City of Englewood, Ohio
I-70 Pump Station Replacement
2019

ADDENDUM 3

May 16, 2019

PLAN CUT AT EL. 931.25

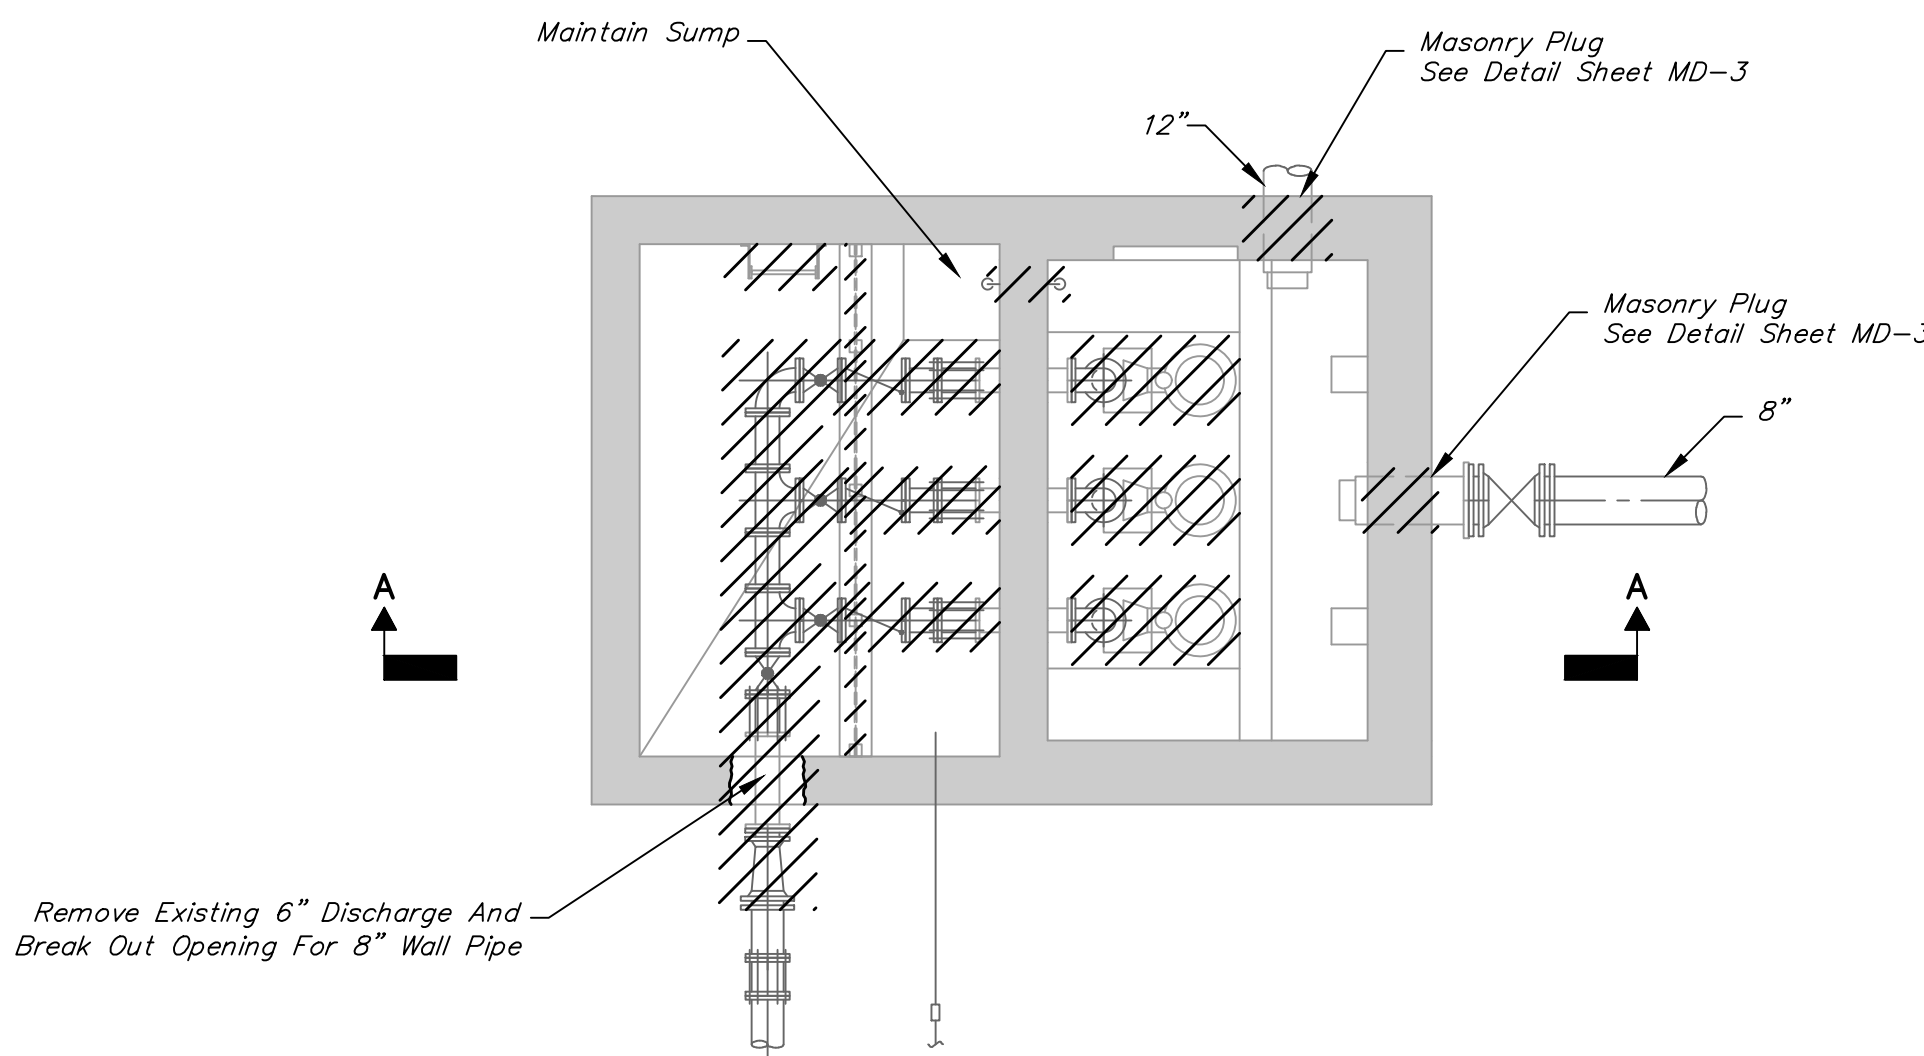
1. There does not appear to be any interior manhole coating called out in the paint schedule.
Manholes will not be coated. See Section C-02552, Par 4.01 for Xypex Additive to be used.
2. There is a vent pipe and an exhaust fan that penetrate the roof. Are they to be removed? Can Roof Patch detail be provided?

The existing exhaust fan will remain in use. See revised drawing R-1 issued as part of this addendum.
3. There is a louver that is shown to be removed from the existing building. Does this need to be filled with masonry?

The existing louver will remain in use and not removed. See revised drawing R-1 issued as part of this addendum.
4. Drawing E-3 calls out a power cable schedule under the notes in the one-line diagram. We cannot locate the schedule in the drawing.

Delete Sheet R-1, Existing Pump Station Removals- Plans and Sections, and Replace with : Revised Sheet R-1.
